UNITED STATES ENVIRONMENTAL PROTECTION AGENCY

WEST LAKE LANDFILL
EPA REVIEW COMMENTS FOR THE
RI/FS WORK PLAN DATED FEBRUARY 28, 1994

PLANNED RAINWATER RUNOFF AND LEACHATE SEEP SAMPLING LOCATIONS WESTLAKE LANDFILL AREAS 1 AND 2, BRIDGETON, MISSOURI

APPROXIMATE LOCATIONS OF PLANNED
RAINWATER RUNOFF AND LEACHATE SAMPLES
AREA 1 & 2 ADJACENT AREAS
WESTLAKE LANDFILL
BRIDGETON, MISSOURI

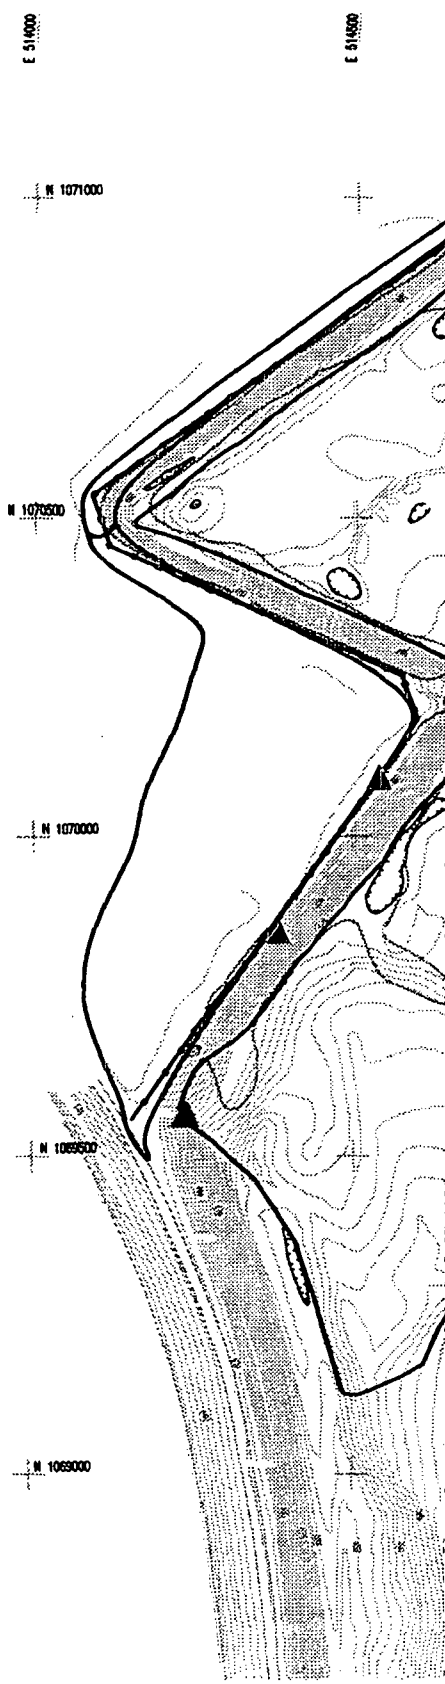
The RI/FS Work Plan (Work Plan) for Westlake Landfill radiological Areas 1 and 2 (Site) addresses the collection of rainwater runoff and sediment samples at locations where rainwater discharges from these radiologically impacted areas, and the sampling of any identified leachate seeps. Planned rainwater sampling locations are to be based on inspections of the Site during rainy weather conditions; leachate seep sampling locations are to be based on routine inspections of the perimeter slopes of the Site.

Field reconnaissance during the time period of October 1994 to March 1995 indicates nine locations where rainwater discharges from the Site (four in Area 1 and five in Area 2), and one leachate seep (Area 2). All of these locations will be sampled in accordance with the Sampling and Analysis Plan (SAP) of the Work Plan (see Appendix A, Section 3.6 and Section 3.7). A map showing the locations of the planned rainwater runoff and sediment sampling, and the leachate seep sampling location, is attached.
